IMPORTANT SAFETY RECALL

NHTSA Recall No. 23V-703

SN723

SUBJECT: Pedestal Mounting Bolts

Figure 1. Area of unit to inspect pedestal to sub-base mounting bolts

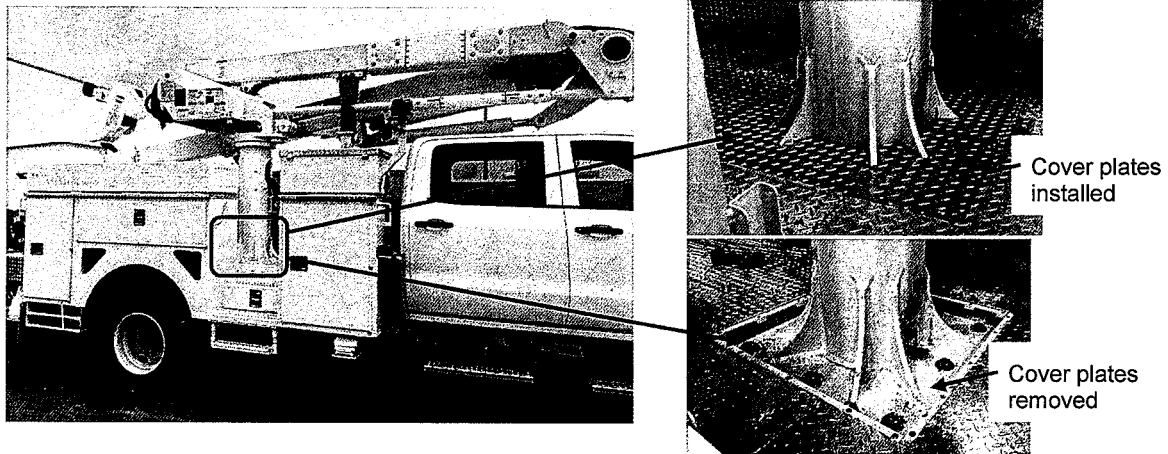
1. Immediately inform all users, operators, and supervisors that the pedestal to sub-base mounting bolts must be inspected before further use. Cover plates at the base of the pedestal may need to be removed to inspect the bolts, refer to Figure 1.

3. Inspect to determine if the pedestal to sub-base mounting bolts are loose.
 - a. The inspection involves a torque check on all pedestal to sub-base mounting bolts using a calibrated torque wrench.

- b. Any loose pedestal to sub-base mounting bolts are to be retorqued using a calibrated torque wrench. Grade 5 bolts are to be retorqued to 300 ft-lbs and grade 8 bolts to 460 ft-lbs.

- c. After retorquing all pedestal to sub-base mounting bolts, apply torque striping across the bolt head and washer to the bolting plate to aid in further visual inspections.

- d. Store the pedestal base cover plates and mounting hardware in a secure location, such as a body compartment, until Field Service Kit Z1702 is installed. Inform users and operators that the opening in the body floor around the pedestal may be a trip hazard until the cover plates can be reinstalled.
